UNITED STATES PATENT AND TRADEMARK OFFICE

10/539,597

| Office Action Summary | Application No. 10/539,597 | Applicant(s) CHOLET ET AL. | |

- 1) ☒ Responsive to communication(s) filed on 5 June 2008.
- 2a) ☒ This action is **FINAL**. 2b) ☐ This action is non-final.
- 3) ☐ Since this application is in condition for allowance except for formal matters, prosecution as to the merits is closed in accordance with the practice under *Ex parte Quayle*, 1935 C.D. 11, 453 O.G. 213.

Figure 1. (Ohtsuki et al.) Chamber 1A detailing Hopper Section

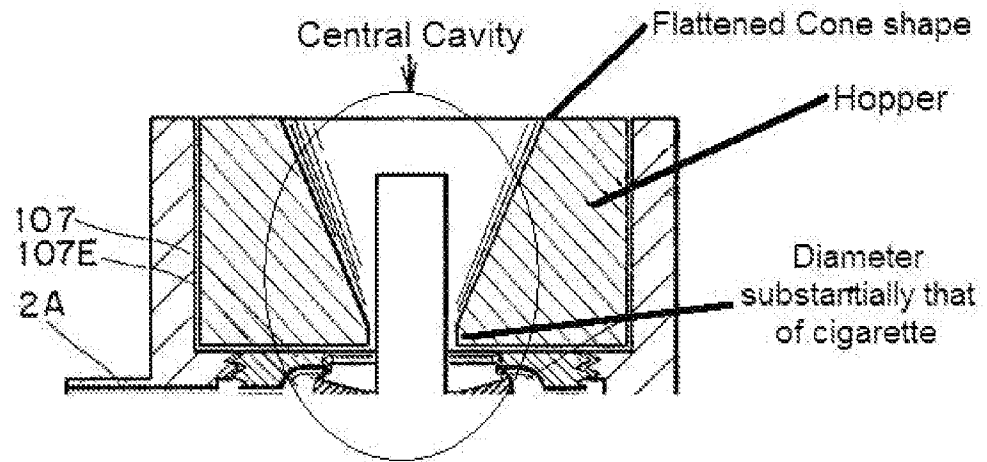
- wherein the sample-holder comprises firstly, a cylindrical structure made of three tubular parts (1A/1B/1C) assembled onto one another, namely:
 - a first part (1A) comprising a hopper (refer to figure 1 below) whose central coaxial cavity comprises a part of flattened cone shape (refer to figure 1 below) followed by a cylindrical part whose diameter is substantially that of the cigarette, the lower part of this hopper comprising an iris diaphragm (107E) as recited in claim 5;

Figure 2. (Ohtsuki et al.) Chamber 1B detailing two respective ends of a tube

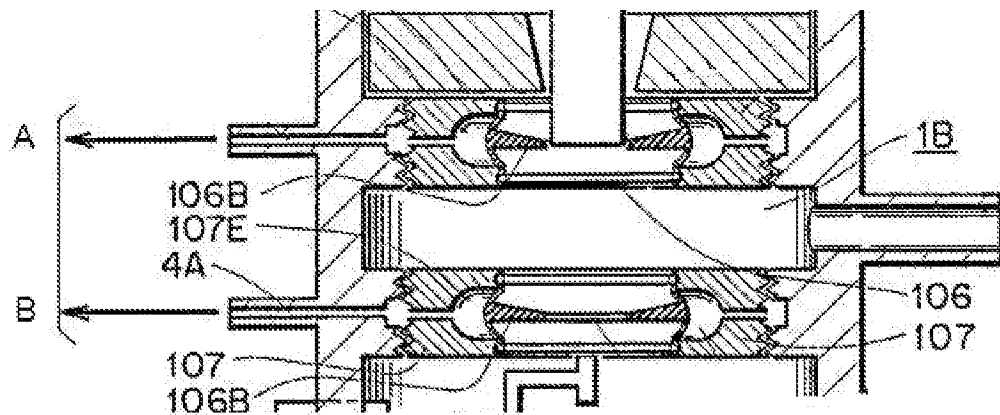
- a second part (1B) consisting of two respective ends of a tube in dielectric material fit with gas-tight assembly, the inner diameter of this tube being slightly larger than the cigarette diameter as recited in claim 5; (**NOTE:** Ohtsuki et al. do not specifically disclose a tube of dielectric material fit however, the instant application uses a separate tube of dielectric material covering a portion of the cigarette within the cavity while being tested. Ohtsuki et al. use sample supporting members (106) of dielectric material to support the cigarette within the cylindrical gas-tight assembly exposing more of the cigarette to the air flow during ventilation testing allowing a highly accurate measurement of ventilation characteristics (col. 2, lines 51-57). Furthermore, Ohtsuki et al. disclose that a support contacting the cigarette by face-contact makes it practically impossible to obtain a highly accurate measurement value (col. 2, lines 35-47). Lastly, the instant disclosure has not stated the criticality of the tube, except that it supports the cigarette in the device during testing. Therefore, since the tube of the instant disclosure and the claims only support the cigarette, the sample supporting

members of Ohtsuki et al. are the functional equivalent and meet the structural limitation used in supporting the cigarette within the gas-tight assembly).
